YIRIBANA LOGISTICS ESTATE

Submissions Report
SSD-10272349

Prepared for
THE GPT GROUP
16th September 2022

Figure 1 Refinement to the exhibited project – Stage 1 Plan

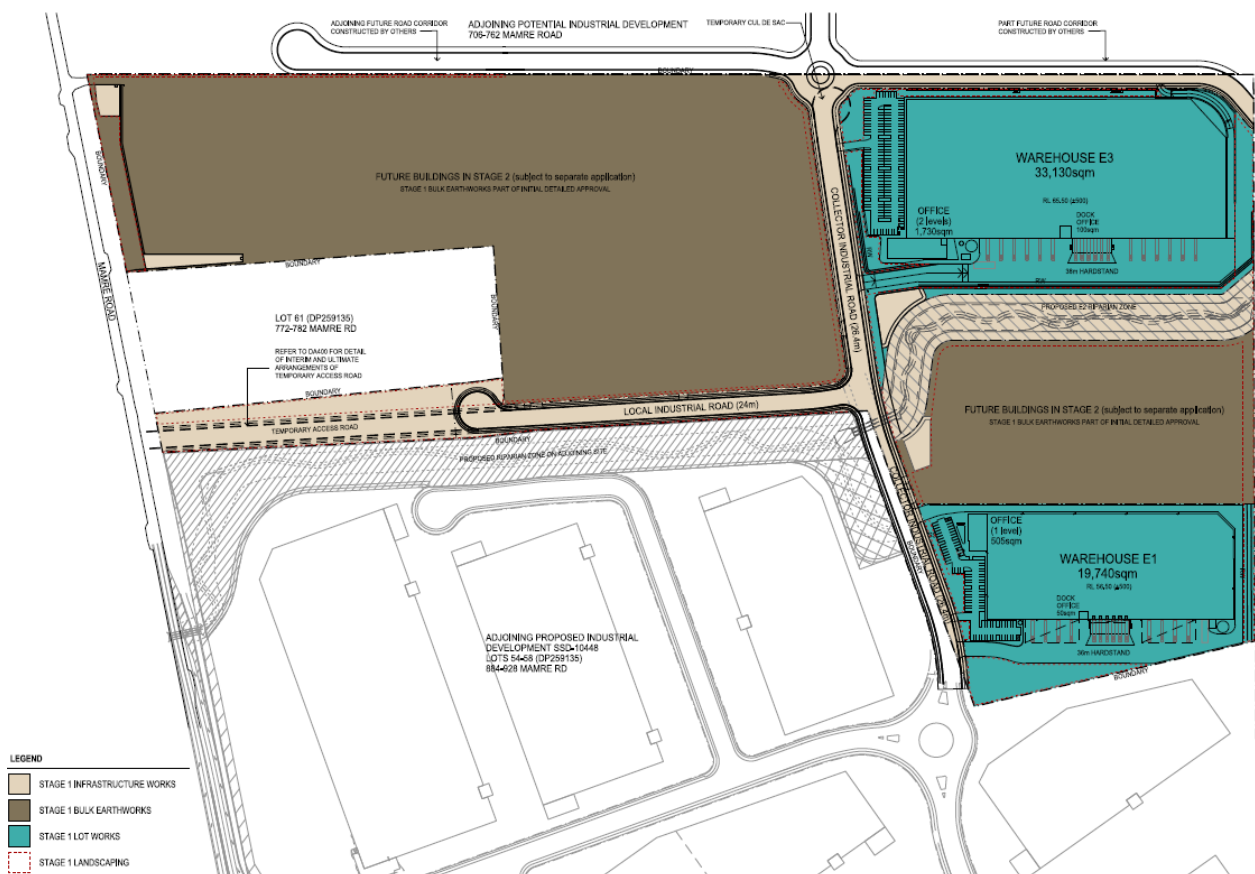
The key refinements and clarifications proposed since public exhibition and in response to submissions made, and as a result of further engagement with DPE include:

- **Refinement to the exhibited project** with the SSD-10272349 only seeking Stage 1 consent with the Concept Master Plan approval no longer being sought. GPT has since acquired 772 Mamre Road, Kemps Creek, and as such will be lodging a subsequent application which includes this site.

- ~~A Concept Master Plan comprising five (5) industrial warehouses and ancillary offices, internal road network, 35m environmental corridor, building locations, GFA, setbacks, car parking and built form parameters.~~
- Detailed development consent for:
 - ~~— Subdivision;~~
 - ~~— Site-wide preparation works including estate-wide clearing of all vegetation and dam-dewatering;~~

Figure 2 Site Layout Plan

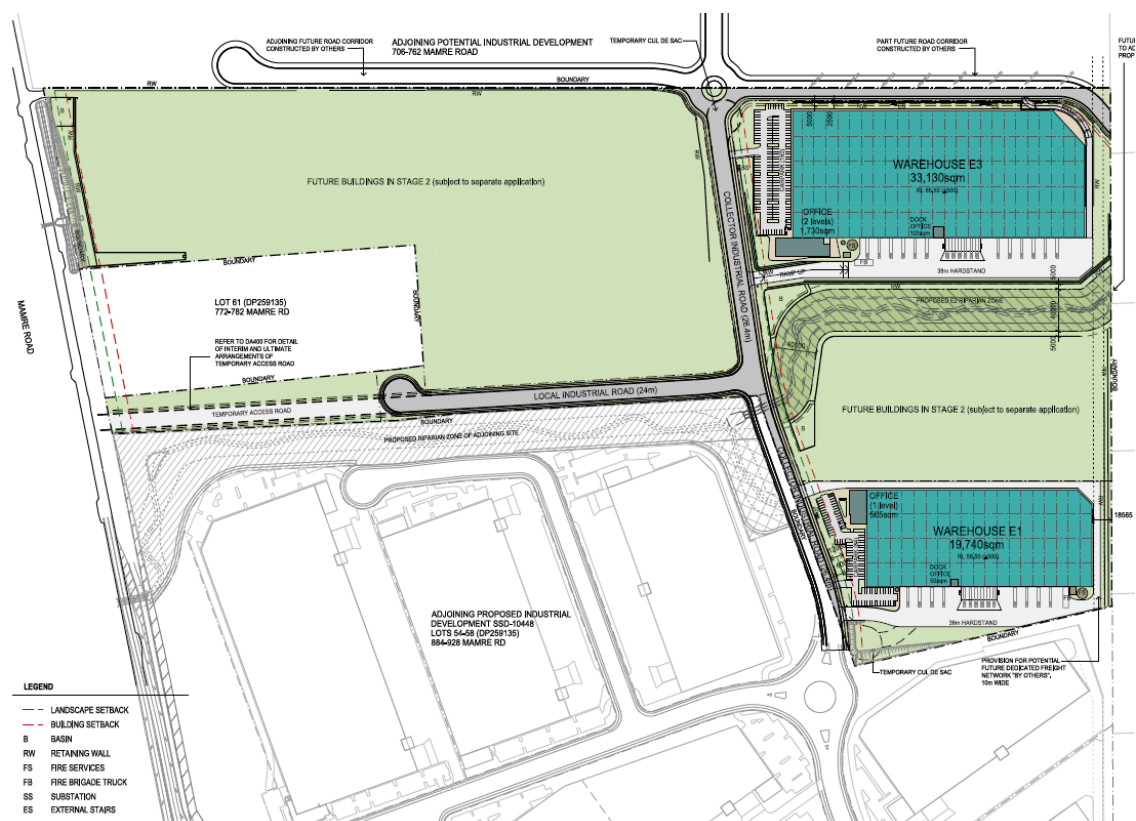
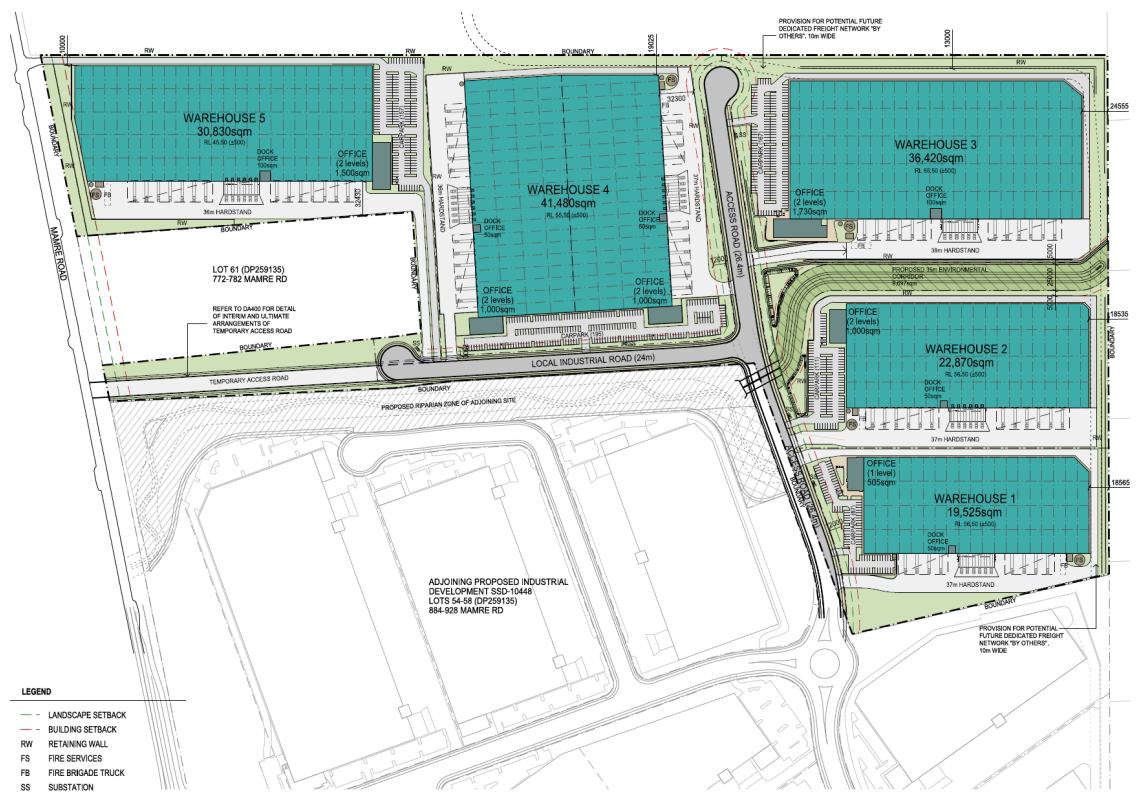
The Master Plan has been amended to incorporate the widening of the E2 riparian corridor and the inclusion of the east-west local road along the northern boundary of the site. These inclusions have resulted in the lot areas and building GFA across the site being updated across the YLE development. The proposed changes are outlined in **Table 4** below.

Refer to **Figure 2** and **Figure 3** for a comparison between exhibited Master Plan as part of EIS and the revised Site Layout Plan as part of this Submissions Report. It is important to note that Warehouses 2, 4 and 5, previously exhibited as part of the Concept Master Plan, have now been withdrawn and is not included as part of this Submissions Report, with approval being sought for Warehouses 1 and 3 only. Refer to the Section 37 Request to Amend SSD-10272349 at **Appendix X** of the Submissions Report.

Figure 6 Proposed E2 riparian corridor

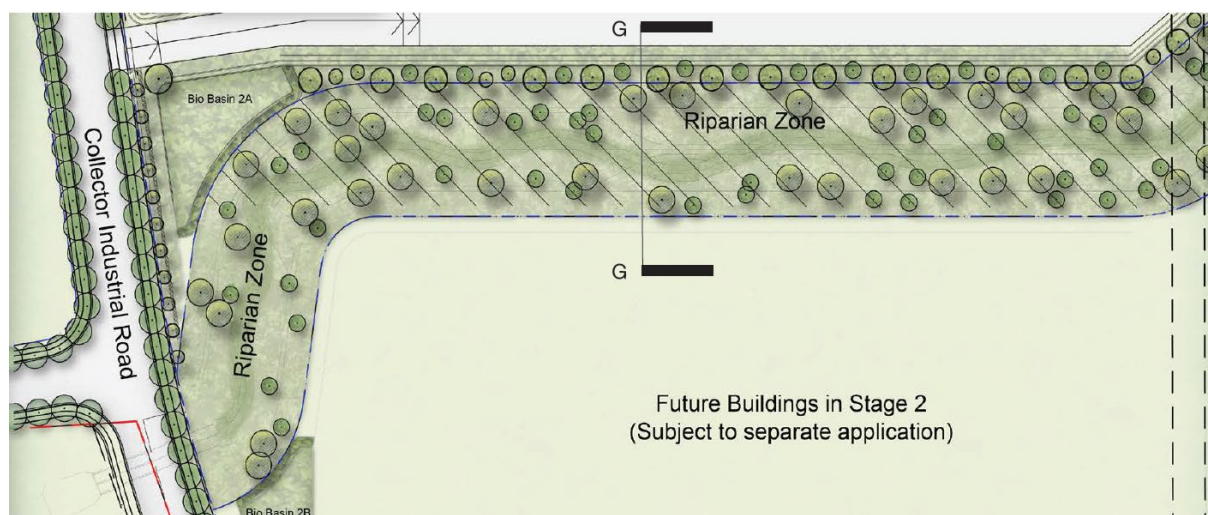
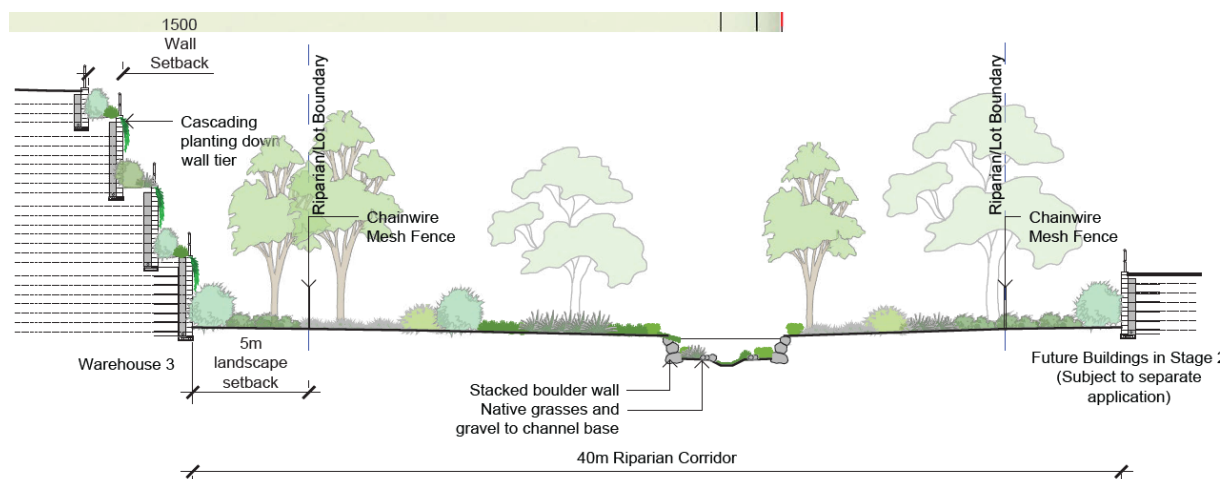
- **Widening of the E2 riparian corridor** to comply with NRAR's requirement for a 40m wide E2 riparian corridor, with additional 5m setbacks on both sides. This consideration and amendment, however, took place prior to the finalisation of the Cumberland Plain Conservation Plan (CPCP), which resulted in the site being biodiversity certified as urban capable land. The E2 riparian corridor is no longer zoned E2 Environmental Conservation, with the entire site now zoned for IN1 General Industrial.

The total area of the E2 riparian corridor has increased from 9,697 m² in the EIS to 15,393 m² within the updated Master Plan within this Submissions Report (refer **Figure 4**).

The total area of the E2 riparian corridor also provides additional E2 area in comparison to the area originally zoned for E2 Environmental Conservation under the WSEA SEPP.

Figure 10 Inclusion of the east-west local road

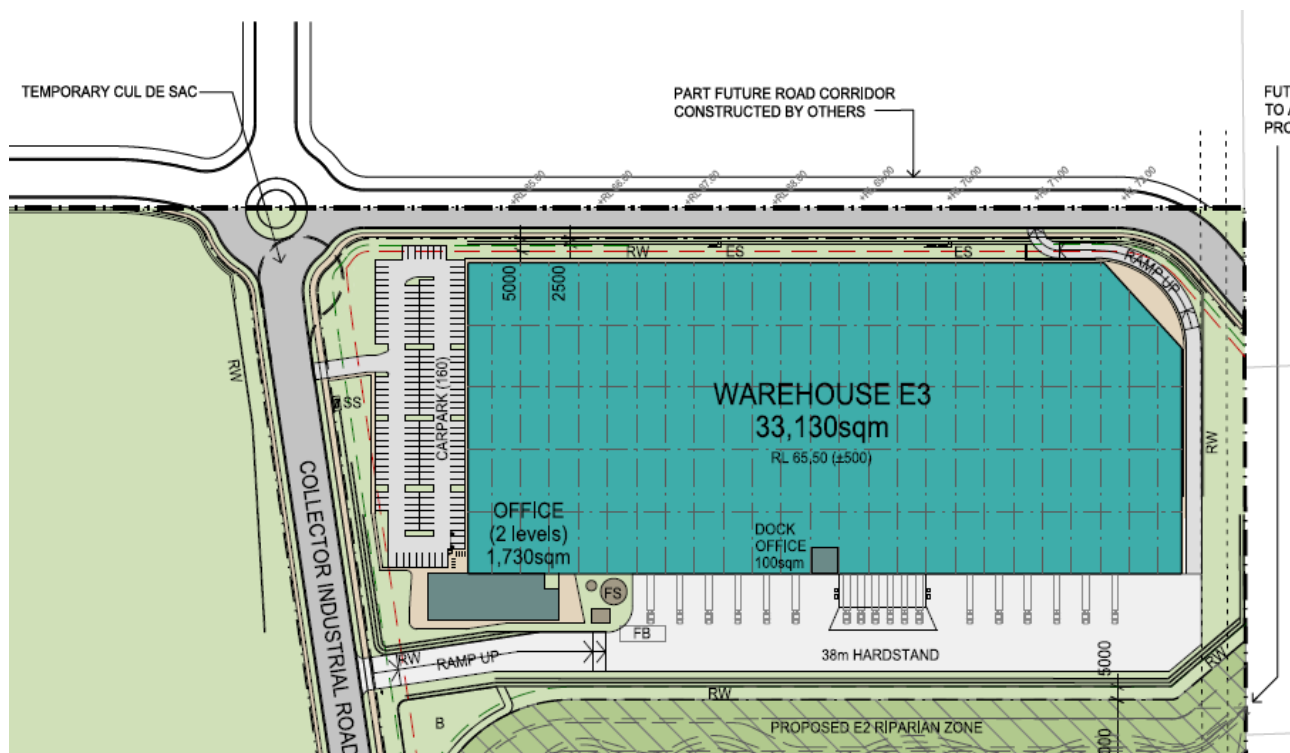
The exhibited Master Plan for the site did not include the local road which runs east-west along the northern boundary of the site, as identified within the MRP DCP Road Network Map. The amended Master Plan as part of this Submissions Report include this new road which will run along the northern cadastral boundary, connecting from the eastern boundary of the site to the north-south collector road within the middle of the site. The east-west road is situated to the immediate north of Warehouse 3 which will have direct frontage, an exit ramp from Lot 3 directly into the local road.

The total area of the road reserve area has increased from 20,594 m² in the EIS to 25,981 m² within the updated Master Plan within this Submissions Report (refer **Figure 10**).

The inclusion of the east-west local road achieves consistency with the MRP DCP. It also assists future delivery of adjacent development sites.

Figure 11 Stormwater Drainage Master Plan and the proposed on-site bio-retention areas

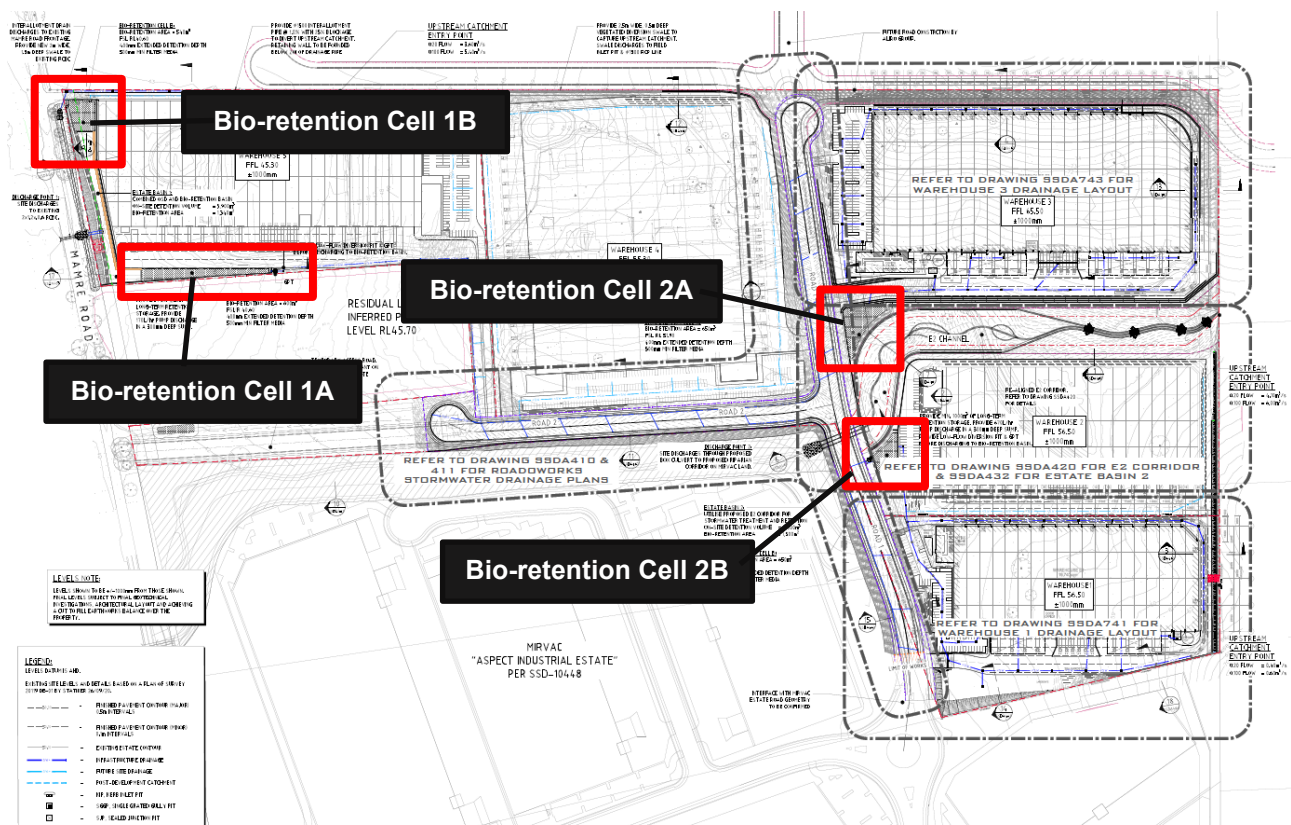
The stormwater detention system and on-site detention basins have been redesigned to ensure waterway health and water sensitive urban design (WSUD) objectives and controls under the MRP DCP are met. The basin arrangements provided as part of the YLE development is comparable to multiple industrial developments within Erskine Park and Eastern Creek, with the added benefits of additional landscaping and improved aesthetics in accordance with the MRP DCP.

GPT acknowledge the appointment of Sydney Water as Storm Water Manager for the MRP. Subject to further information, GPT reserve the right to opt into the Sydney Water regional solution and subject modification remove the stormwater detention system and on-site detention basins as proposed.

It is noted that given the recent announcement of Sydney Water as the waterway manager, it is anticipated that some documented measures (including additional storage and rainwater tanks) would be temporary only, and subject to either removal if constructed or future SSDA Modifications following Sydney Water's development scheme plans being exhibited and estate management measures and objectives being adjusted to suit the intended regional scheme.

Figure 14 Mirvac SSD-10448 – Interim and ultimate alignment of the E2 riparian corridor

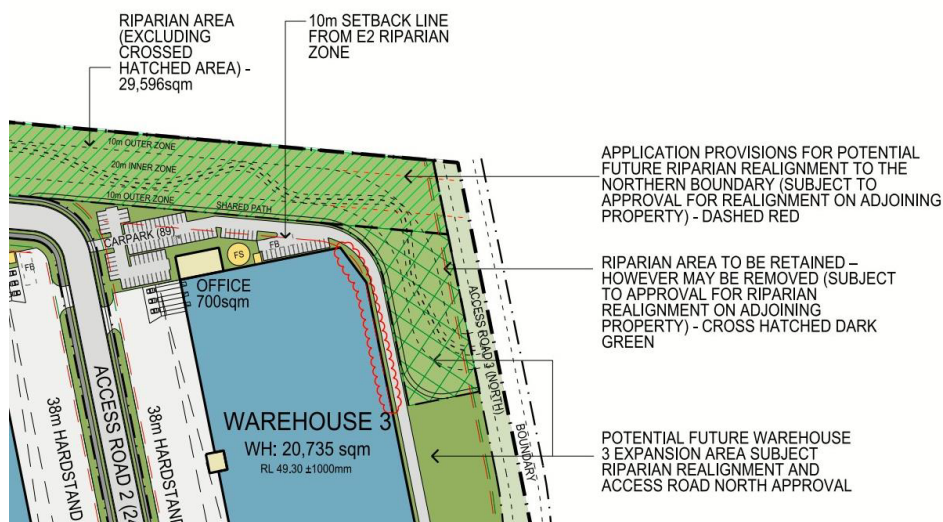
It is noted that SSD-10448 considers the interim condition between their development being approved and construction occurring prior to that of GPT Group. Under these circumstances the head of the channel would need to align with the existing watercourse, until such time as the GPT Group development is approved and construction works to realign the water course are complete.

The SSD-10448 "SSDA Estate Masterplan" by SBA Architects (ref 19210 MP02) shows both the interim and ultimate alignments of the E2 corridor. Refer to **Figure 9** below for the excerpt from the noted plan for reference.

Figure 15 Mirvac SSD-10448 – North-south road which is split across the GPT and Mirvac sites

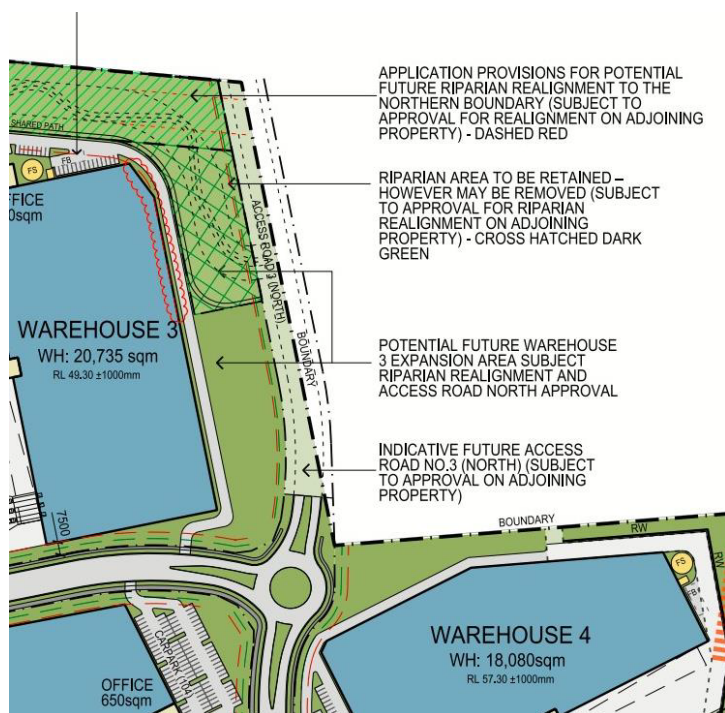
Clarification is required on the access arrangements for Warehouse 1. The site layout plans depict a half road along the frontage of proposed Warehouse 1. Will this half road be designed to accommodate two-way operational traffic from Warehouse 1 until the full road is delivered? It is unclear how access to Warehouse 1 for both construction and operational traffic will be achieved prior to the delivery of the full North-South Road.

It is noted that positive engagement between GPT and Mirvac continues on delivery of road networks and connection of the E2 corridor. Coordination of alignments, based on current level of information, has been undertaken between GPT Group and Mirvac and included in the design layout. Mirvac have also maintained an E2 corridor width of 40m. It is noted that final coordination of alignments of roadways and shared paths will be required as design progresses to construction and during post approval/ construction certificate stage of the development. At this time, it is understood that Mirvac have agreed to submit the relevant application to relation to the proposed road, within 3 months of approval received for the SSD. It is also noted that GPT and Mirvac have had discussions with DPE Major Projects team in relation to the delivery of the road connections.

Refer to **Figure 10** below for the noted Mirvac SSD-10448 plan for reference.
